SUBJECT: POINT BEACH NUCLEAR POWER PLANT, UNITS 1 AND 2 - EVALUATION
OF EVENT NOTIFICATION 42129 (TAC NOS. MC9035 AND MC9036)

SAFETY EVALUATION BY THE OFFICE OF NUCLEAR REACTOR REGULATION

RELATED TO EVENT NOTIFICATION 42129

POINT BEACH NUCLEAR PLANT, UNITS 1 AND 2

Figure 1. Valve Closed

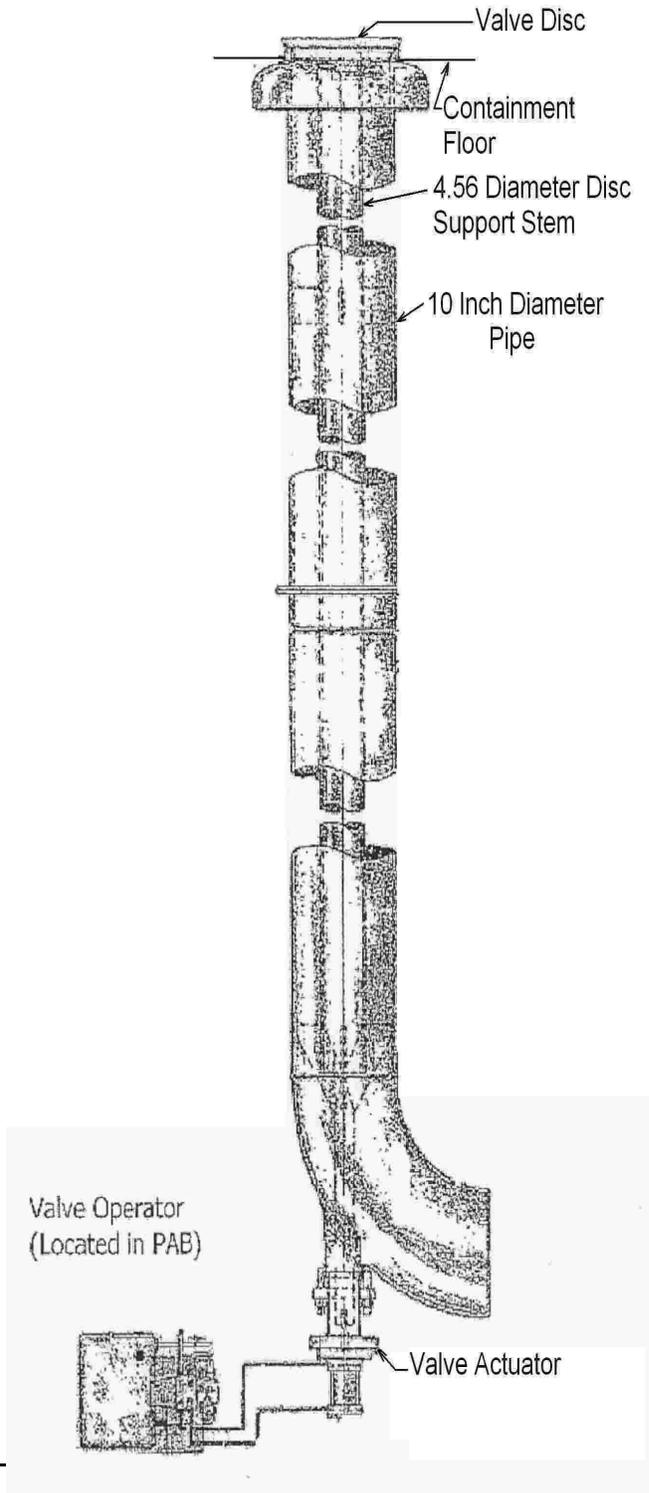
The containment sump recirculation isolation valve (SI-850) is illustrated in the closed position in Figure 1. It consists of a vertical 10-inch diameter pipe with an upper end that terminates at the containment floor. This end is closed by a 12.065-inch diameter disc so that, when closed, the plate is essentially flush with the containment floor. The disc is connected to a 4.56-inch outer diameter valve stem that is, in turn, connected to an actuator located about 18 feet below the disc. The valve will provide a full open stroke of at least 2 inches and the maximum possible stroke is 2.5 inches. The upper end of the valve is covered by a 36-inch high, 13.5-inch diameter screen that is closed by a flat plate at the top.

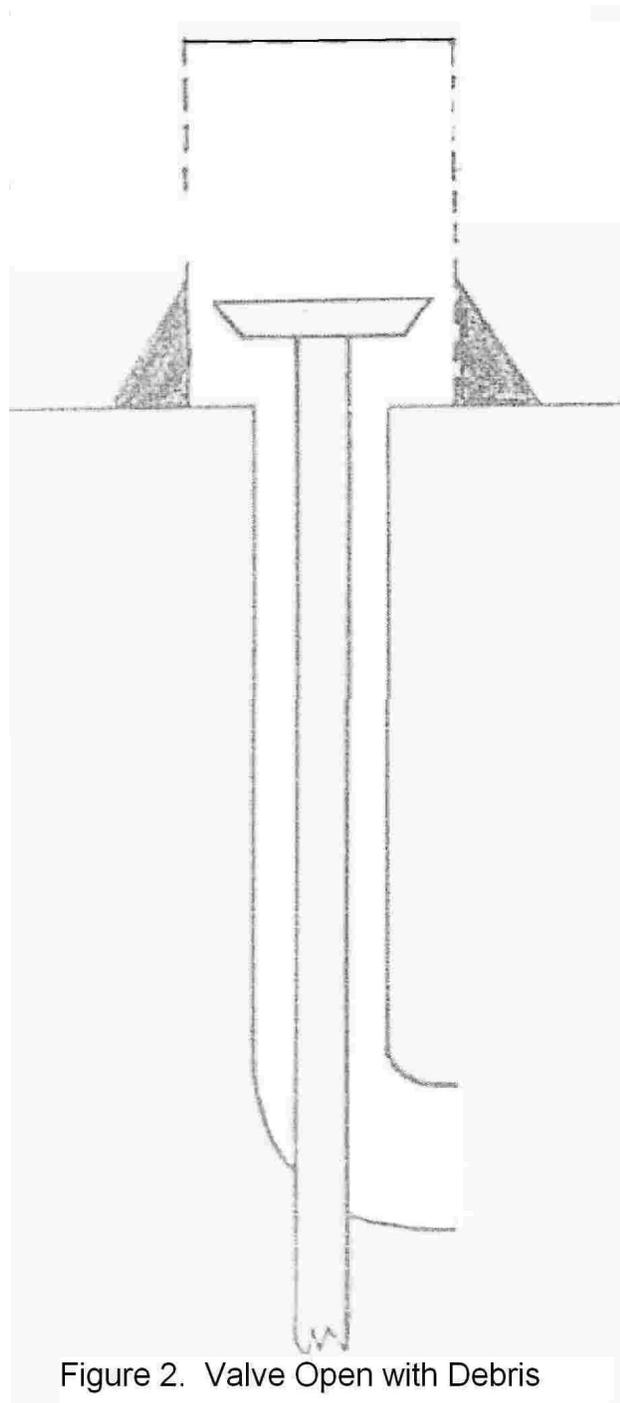
Figure 2 illustrates the postulated buildup of a debris collar around the base of the screen that blocks direct flow along the bottom of containment into the valve. In this configuration, water must pass through the screen above the valve, flow downward through the annulus defined by the valve disc and the screen, and then turn to flow horizontally toward the vertical portion of the valve. The additional turns and the annulus cause a static pressure drop that does not exist if the screen is fully unblocked. Further, the increased velocity in the annulus results in a dynamic

pressure change that, when combined with the decreased static pressure, may cause flashing. Flashing, in turn, would cause a further decrease in static pressure and may result in loss of adequate NPSH at the ECCS pumps.

NMC calculated that formation of a debris collar would increase differential pressure by 4.8 ft of water so that the total pressure drop through the valve would be 7.7 ft. NMC stated that previous calculations showed the NPSH margin was 10.64 ft. It added a previously neglected 3.22 ft of submergence and concluded that there was in excess of 9 ft of NPSH margin at the RHR pumps when operated at a maximum permissible flow rate of 1582 gpm. It further concluded that flashing in the annular gap would be prevented if containment pressure was greater than about 1.5 psig.
